STAFF REPORT

SUBJECT: Avani Neighborhood AZ, PP
H-2023-0049

Annexation of 35.086 acres of land to the R-15 (Medium-high-density residential) zoning district; and Preliminary Plat consisting of 256 building lots and 25 common lots on 33.71-acres of land in the R-15 zoning district for Avani Neighborhood Subdivision.

NOTE: Staff is recommending denial of the project because the applicant’s design (plat and elevations) is inconsistent with the design elements outlined in the TMISAP. The applicant has been made aware of Staff’s concerns and has elected to forego some of Staff’s recommended changes to gain a favorable recommendation. Below provides the basis for Staff’s recommendation; however, the Commission and Council should rely on all relevant information when determining if this project is consistent with the Plan and open to allowing deviations from the design elements as desired by the Applicant.

FIGURE 1

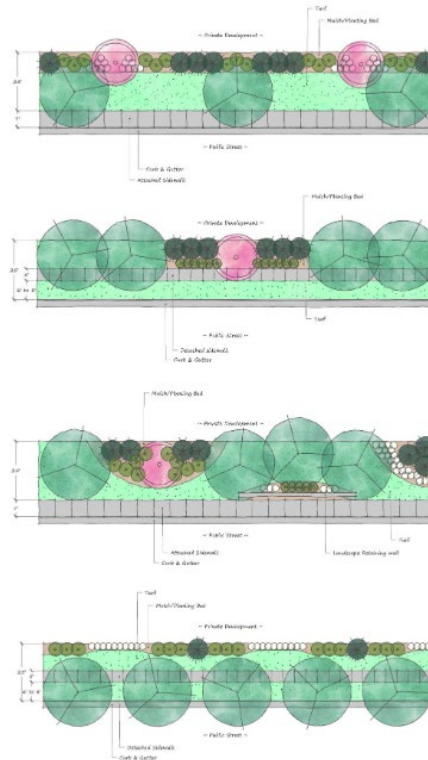
Landscaping (UDC [11-3B](#)): A 25-foot wide street buffer is required is required along all arterial streets (i.e. S. Black Cat Road) in residential districts. A 20-foot wide street buffer is required along all collector streets (i.e. Vantage Point Way) a collector street, per UDC [Table 11-2D-7](#), landscaped per the *updated* standards listed in UDC [11-3B-7C](#). **The proposed buffer along the southern half of Black Cat Road appears to be 20-feet in width and should be 25-feet in width. The 20-foot wide buffer along the new collector street (Vanguard Way) appears to meet the requirements of the UDC code; however, there is a lack of a combination of planters (shrubs and rock mulch) within both of the buffers (refer to the figures below).**

C. Preliminary Plat (dated: 10/18/23) – NOT APPROVED

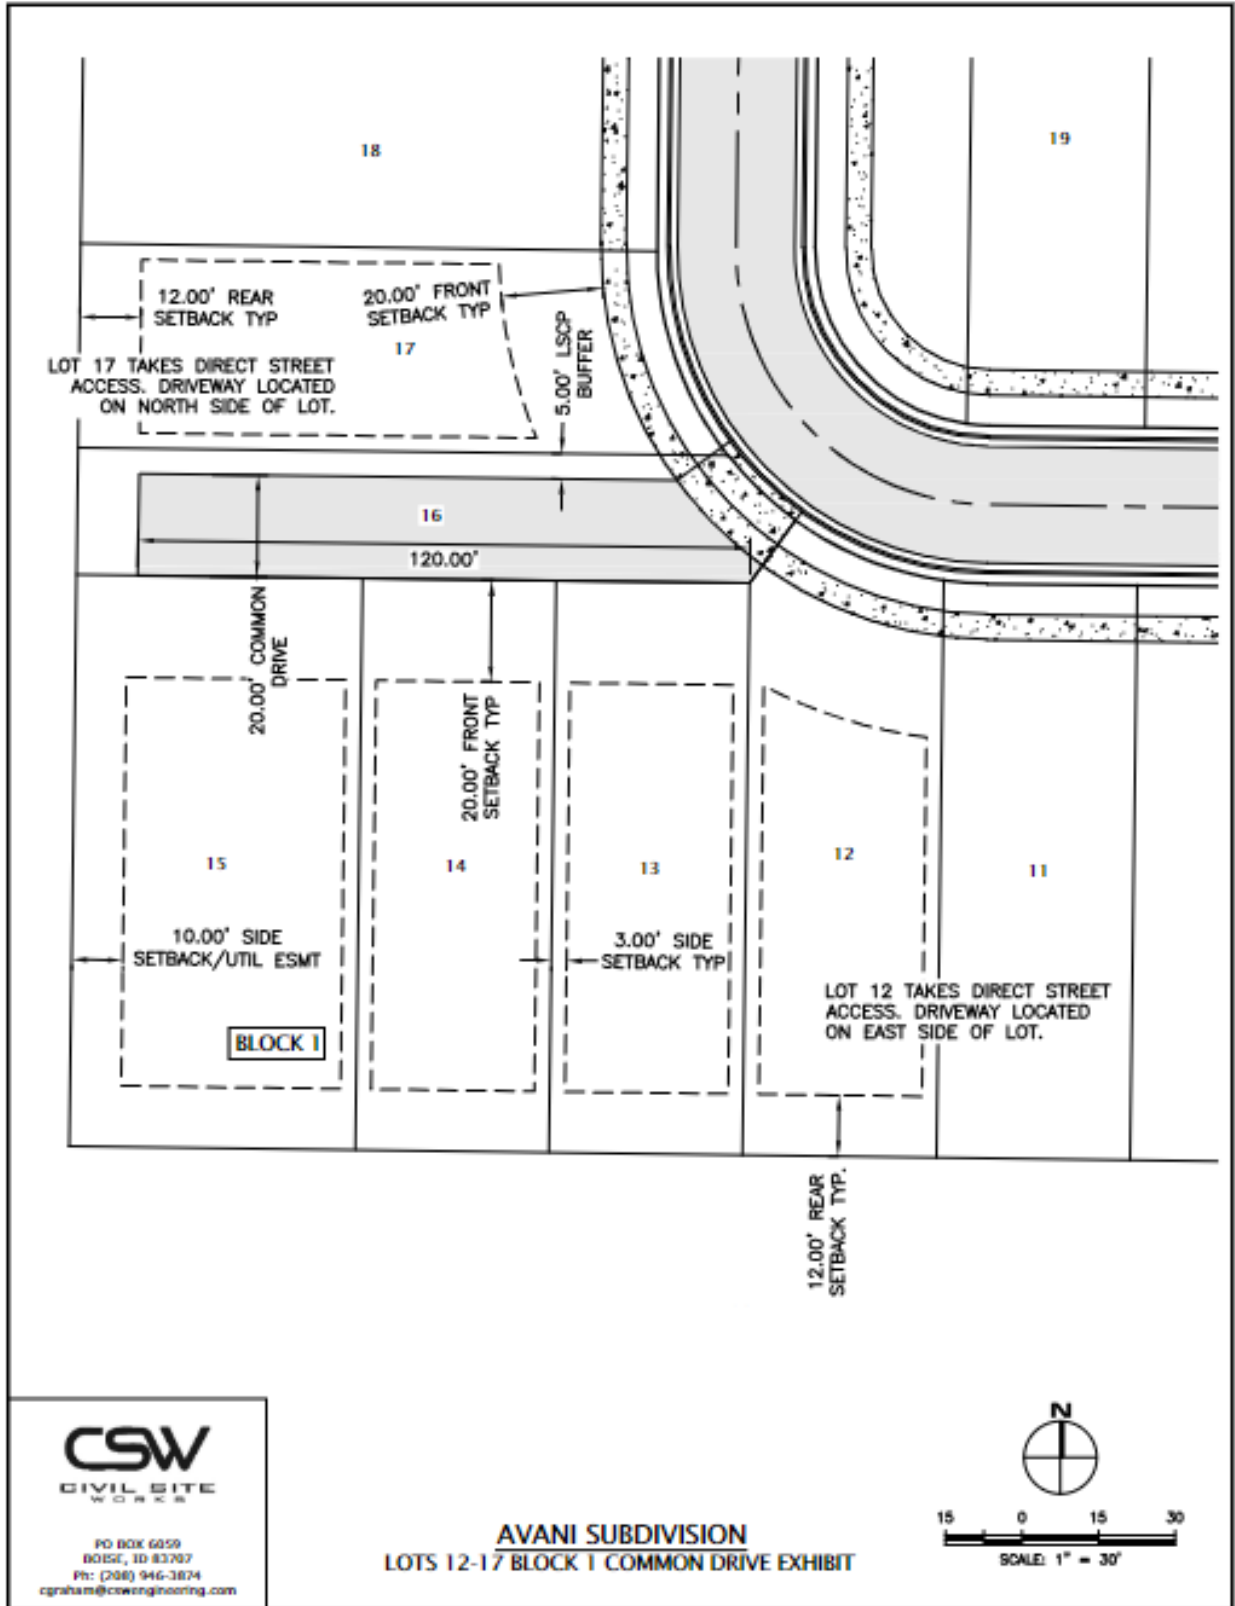
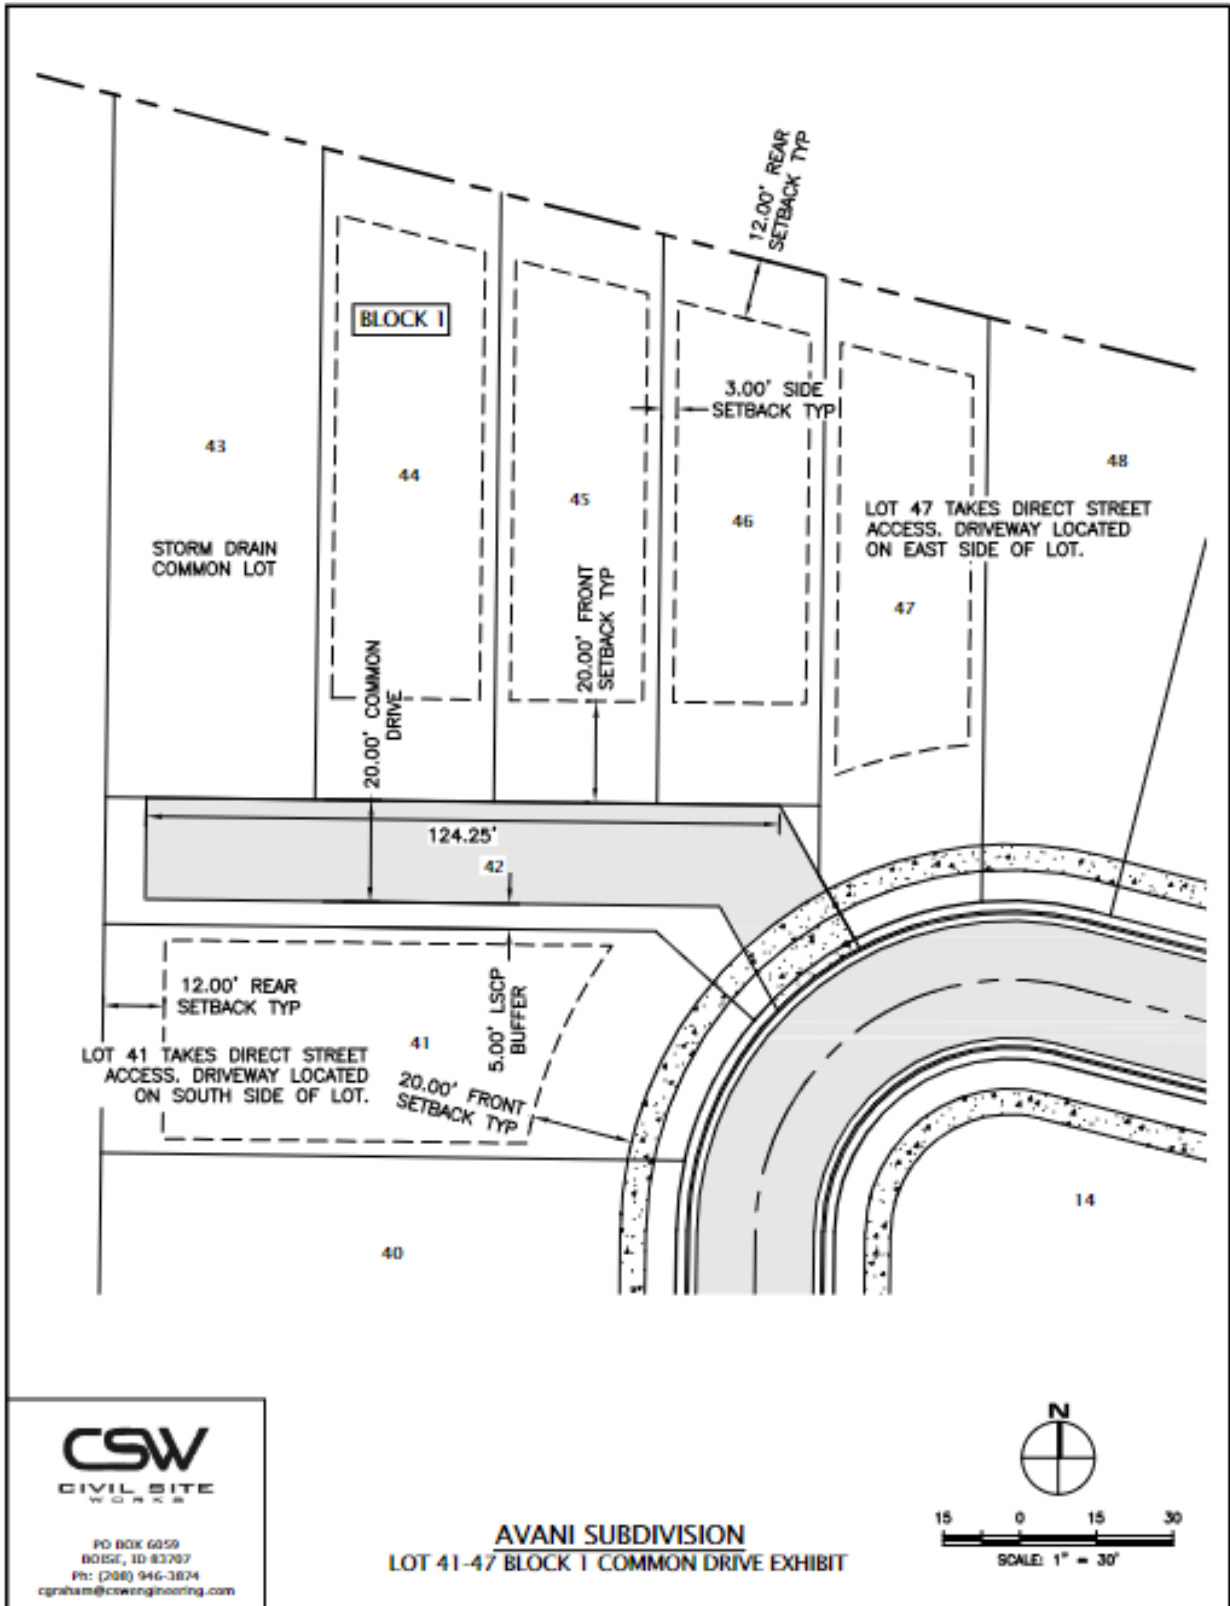
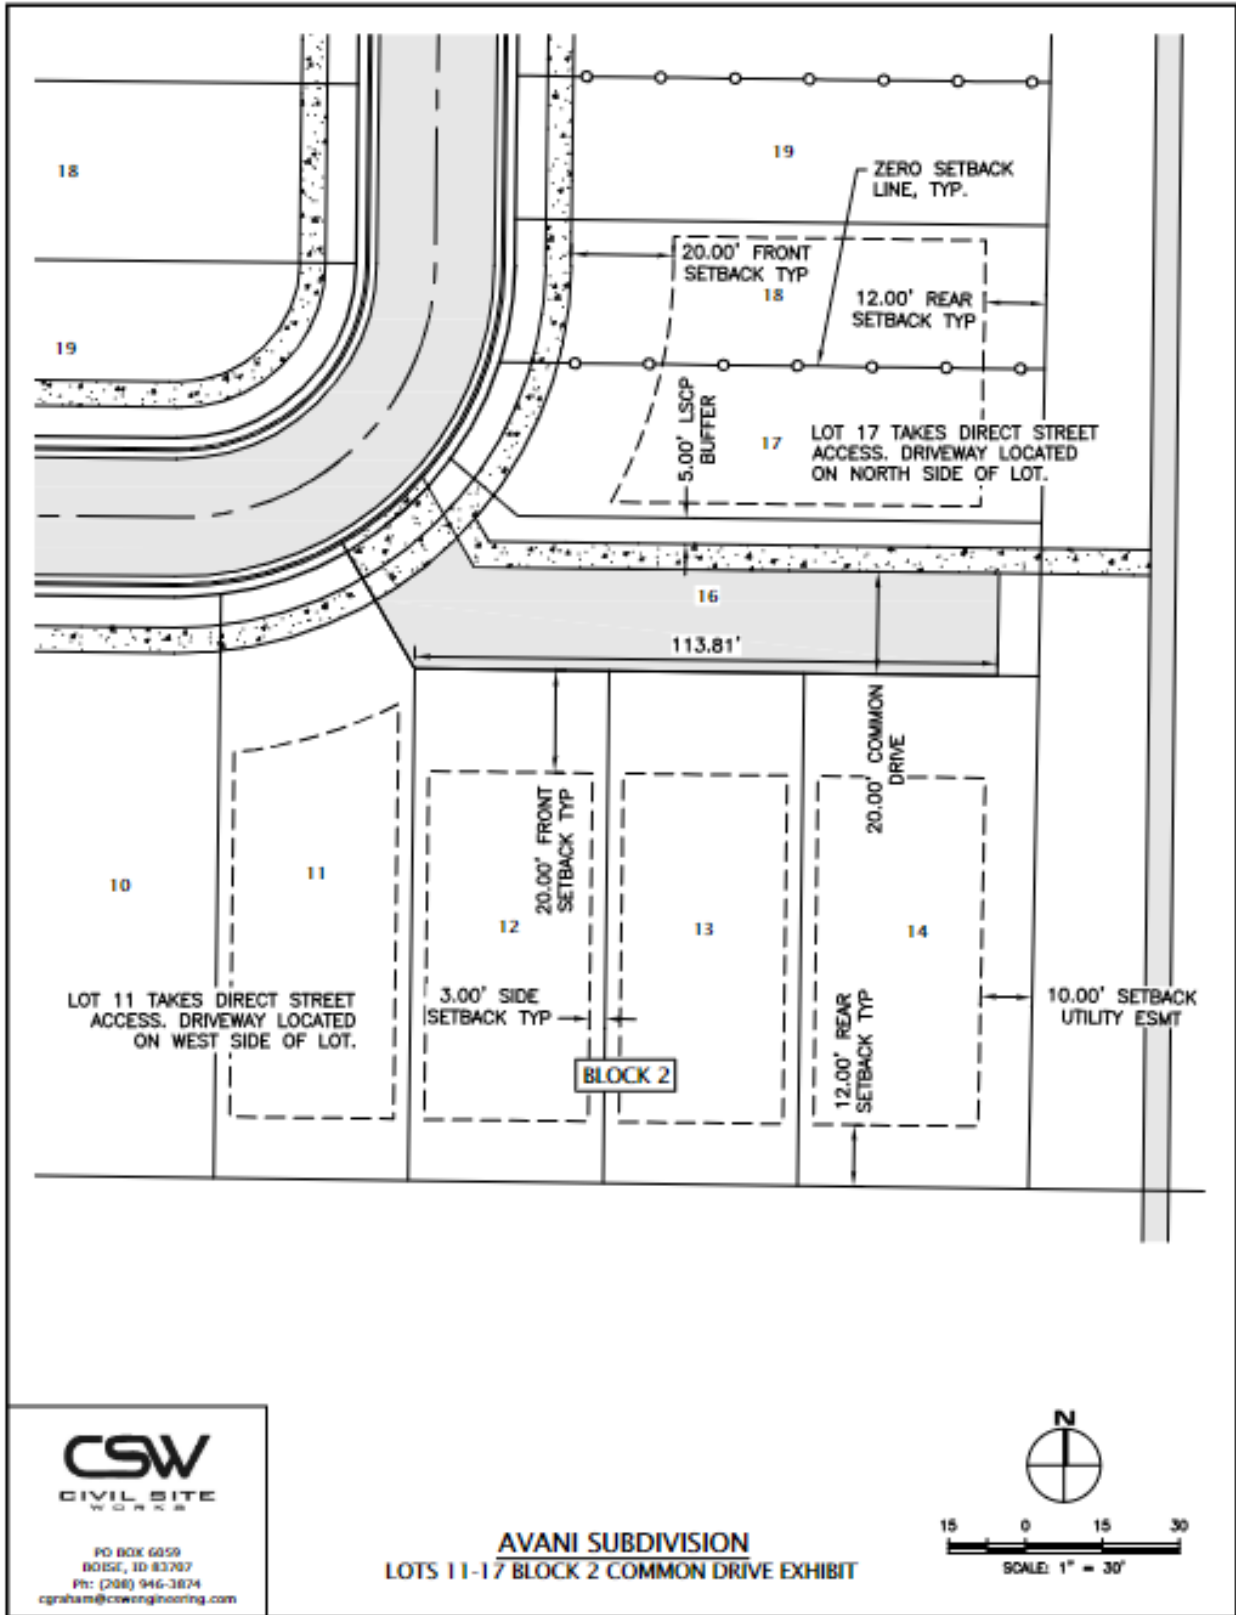
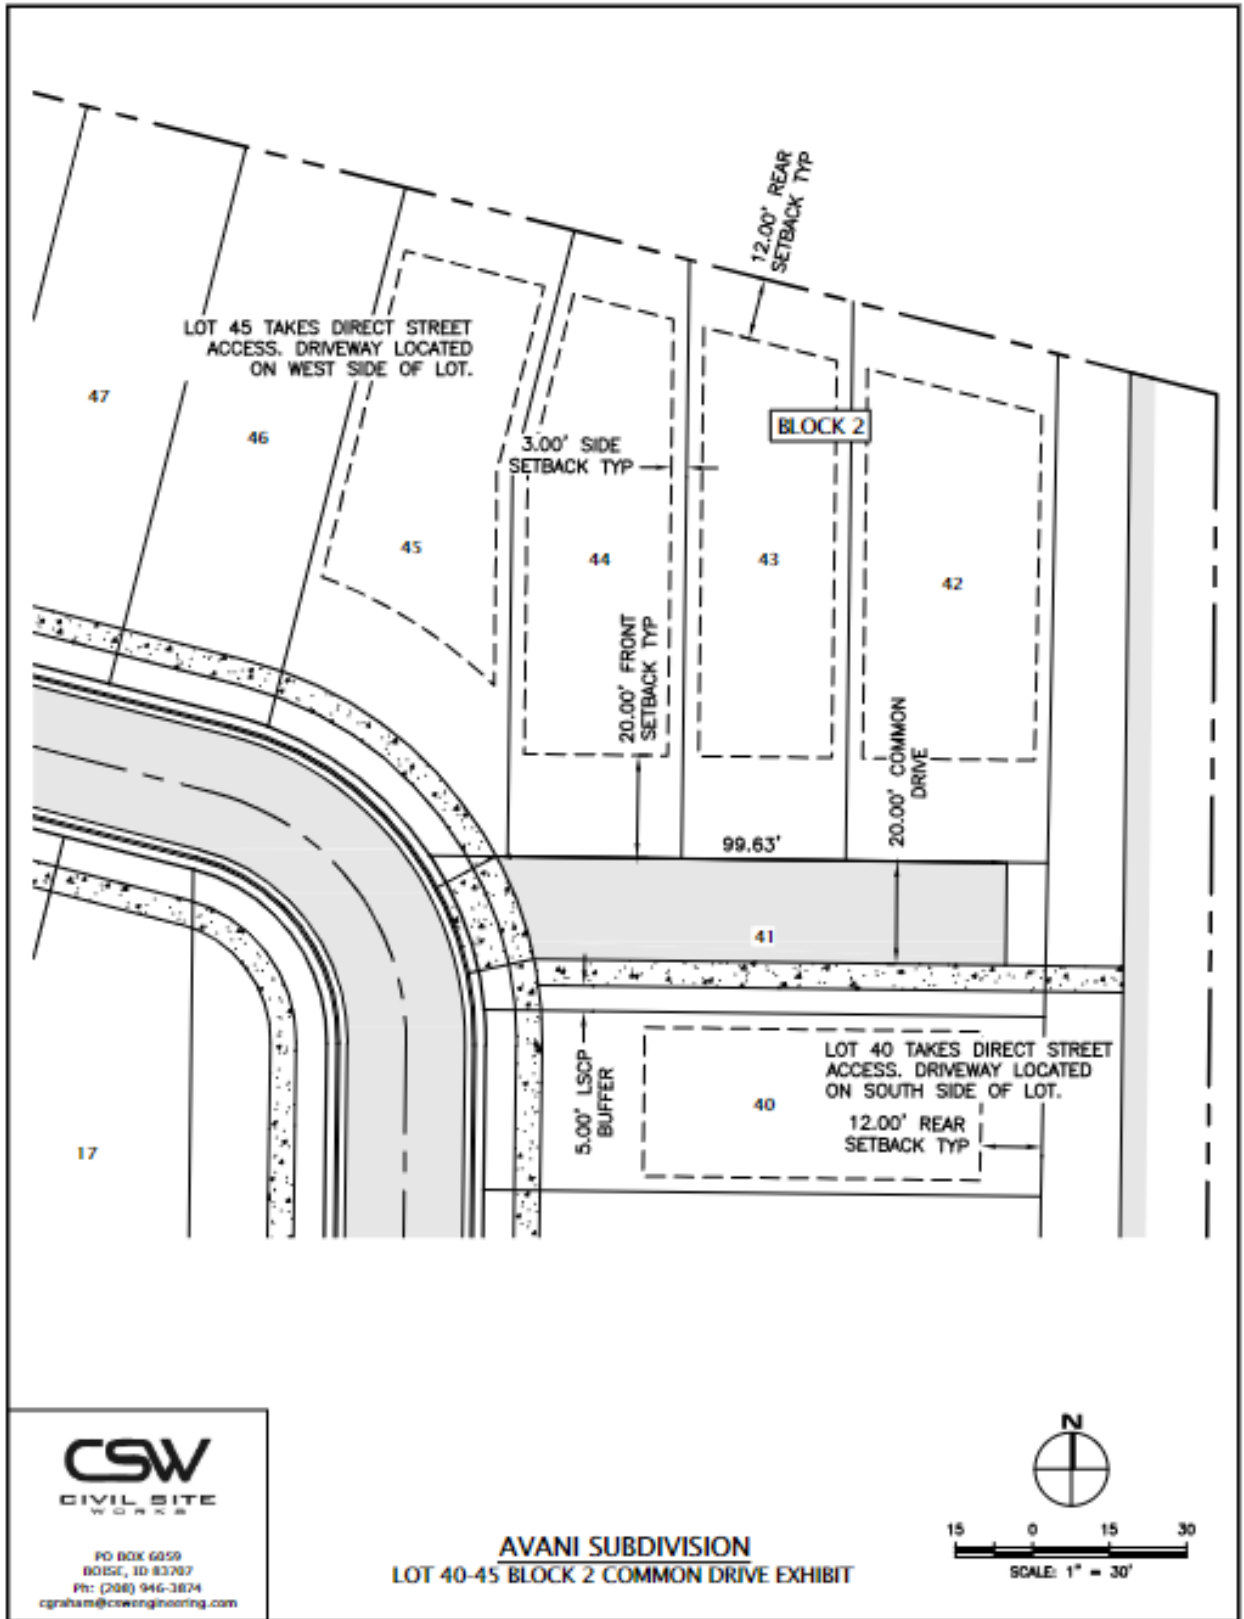
Local streets, alleys, and common drives are proposed internally for access to the proposed residential units. **Staff believes the plat should incorporate more ally-loaded lots however, the Applicant believes there isn’t a market for this type of housing and has elected to limit the number of alley-loaded homes to ten (10) which is inconsistent with the Plan.**

The proposed residential use and mix of housing types may be consistent with the MHDR FLUM designation; **however, the proposed density of 7.59 is below the target density of 12 dwelling units per acre. The proposed architectural design does not comply with the TND guidelines in the TMISAP, as discussed above. Development in this area should conform to these guidelines in order to be deemed consistent with the Plan and determine if it is in the City’s best interest to annex this property.**

The Applicant is proposing one (1) curb cut-off of Vantage Point Way, a planned collector street in the TMISAP. In accordance with UDC 11-3A-3 (Access to streets), multiple accesses off an arterial and/or collector roadway shall be restricted. The Applicant has proposed an emergency access only off of Black Cat Road and has included a stub street to the north (Street H) for potential future access. **Staff recommends that the Applicant collaborates with the property owner to the east to consider incorporating a potential stub street on the east side of this site for connectivity to the future Medium-High Density Residential Development, subject to approval by ACHD.**

Common Driveway (UDC [11-6C-3D](#)): Six (6) common driveways are proposed within the development of the site on Lot 42, Block 1, Lot 16, Block 1, Lot 41, Block 2, Lot 33, Block 2, Lot 16, Block, 2, and Lot 23, Block 5. Common driveways are allowed to serve a maximum of four (4) dwelling units; in no case shall more than three (3) dwelling units be located on one (1) side of the driveway. **A total of four (4) dwelling units are proposed on the south side of driveway for Lot 23, Block 5; the final plat and common driveway exhibit shall be revised to depict a maximum of three (3) units on one (1) side of the driveway as required; or, alternative compliance may be requested as set forth in UDC [11-5B-5](#).**

to comply with this requirement. Additionally, the common driveway located at the southwest corner of the development should incorporate a sidewalk adjacent to the 5-foot landscape buffer connecting to the 10-foot wide pathway along S. Black Cat Road to enhance walkability within the neighborhood.
